# STAFF RECOMMENDATION

NCPC File No. 6786

## DIAMOND TEAGUE PARK

October 25, 2007

PARK CONCEPT SITE PLAN

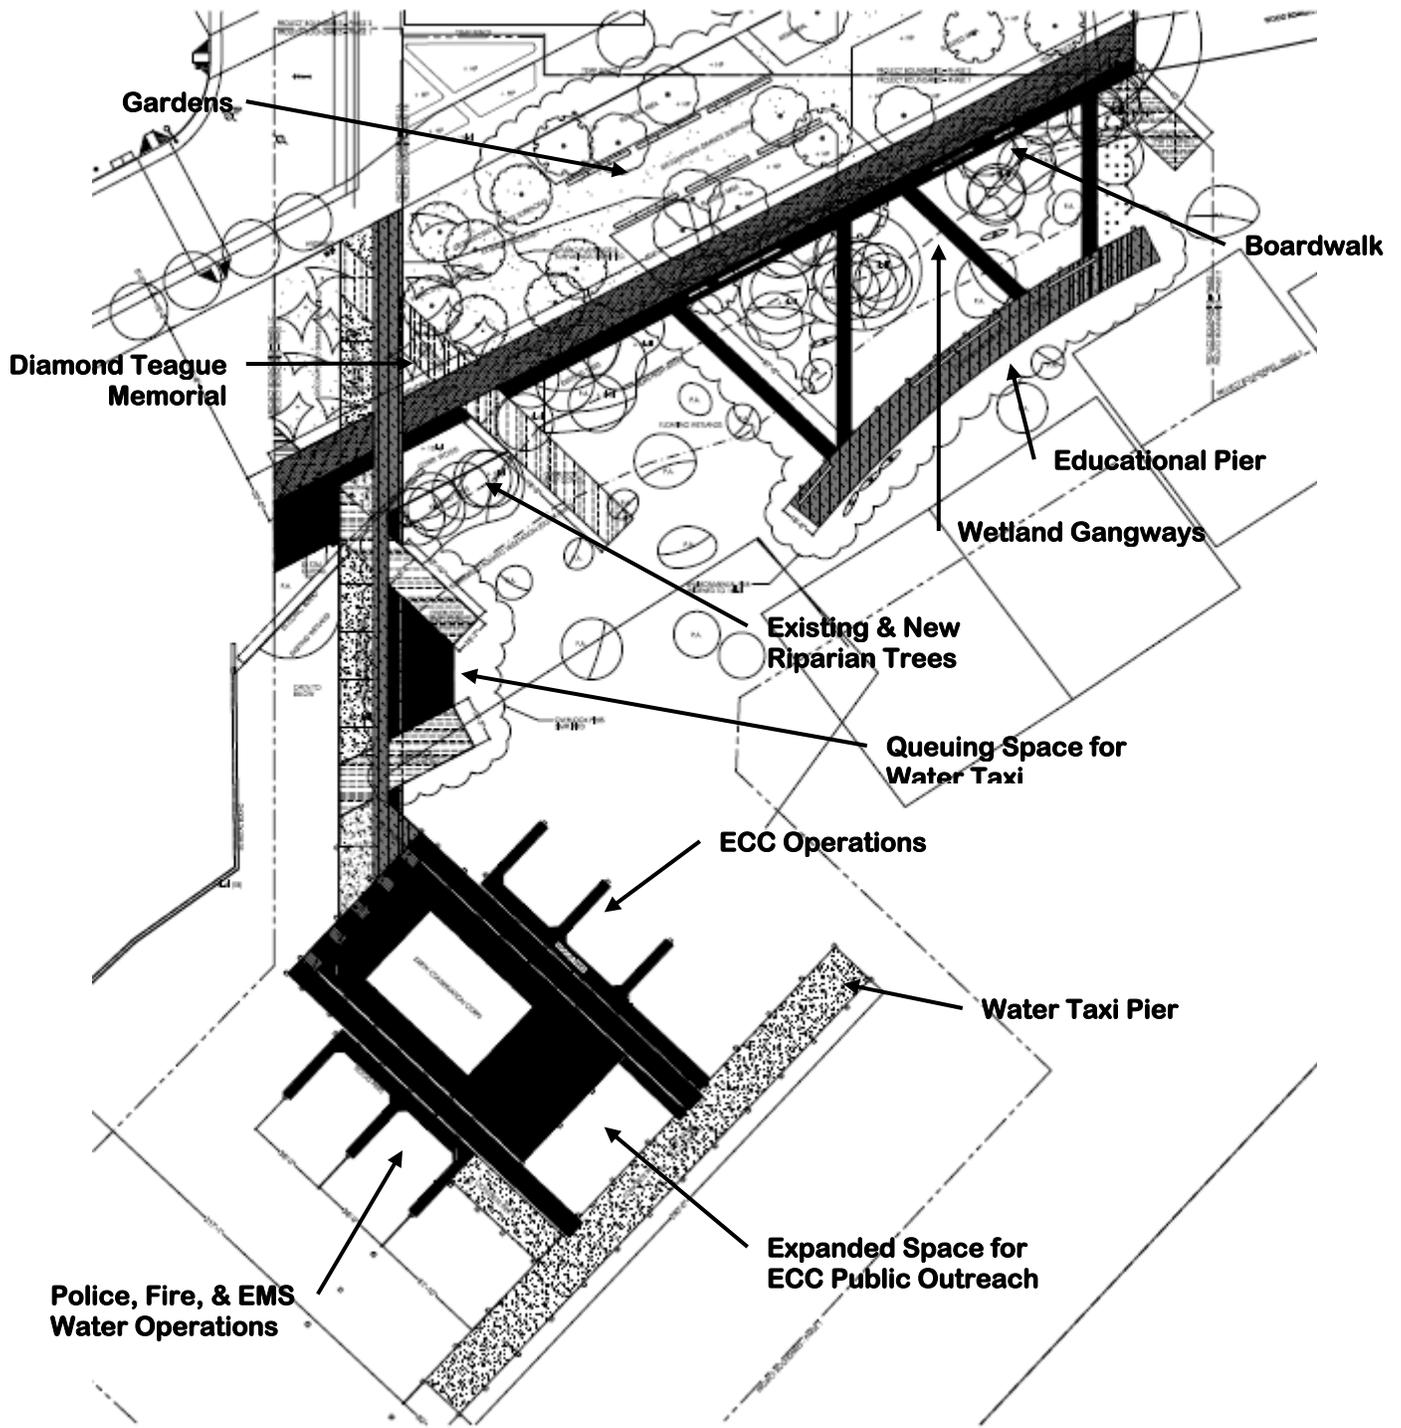
The Commission of Fine Arts reviewed the proposal at its September 20, 2007 meeting. The Commission members commented that the park should be designed to accommodate large groups arriving or departing the stadium and recommended that the open spaces and internal connections be larger in scale and recommended that simplifying and strengthening these features would improve the design. The Commission supported the concept of maintaining the existing line of the riverbank on the site and did not object to the type and configuration of the proposed piers and floating docks.

In response to the Commission's comments, the proposal has since been revised with a widening of the boardwalk along the river (from 20' to 30'); a widening of the smaller, floating dock to the East; and a simplification of the design of the upland park area.

**PARK CONCEPT SECTION**  
**RELATIONSHIP OF PARK TO GRAND STAIR OF NATIONALS' BALLPARK**

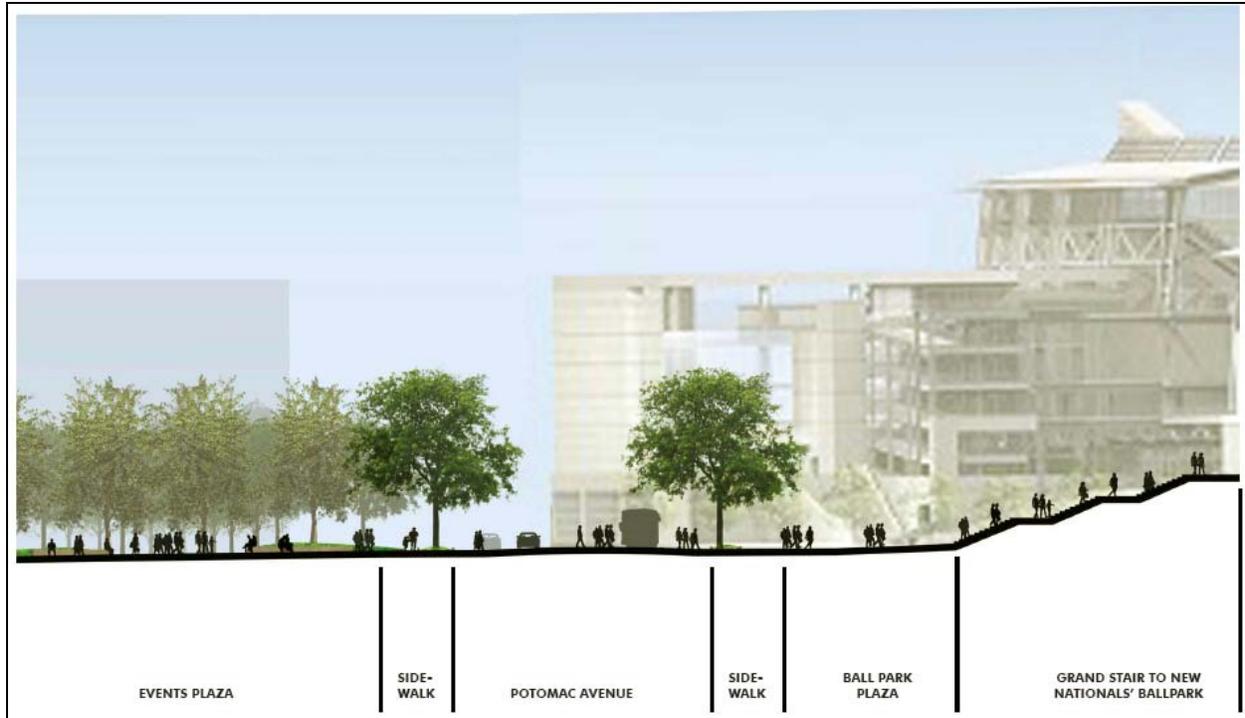
The Park also provides access from the neighborhood to the river's edge, reinforcing the enhancement of pedestrian links between the National Mall and the Anacostia River as promoted in NCPC's *Legacy Plan*, *Federal Capital Improvements Plan* and *Comprehensive Plan for the National Capital: Federal Elements*. In addition, the program for the Park anticipates high numbers of people recreating before and after ballgames, utilizing the water taxi service, and attending baseball associated events and other gathering activities. **Staff recommends** that the Park reinforces the link between the Anacostia River, the neighborhood, and the grand staircase of the stadium across Potomac Avenue SE with a design of the plaza area that maintains and enhances ground-level pedestrian views and access between the stadium and the river.
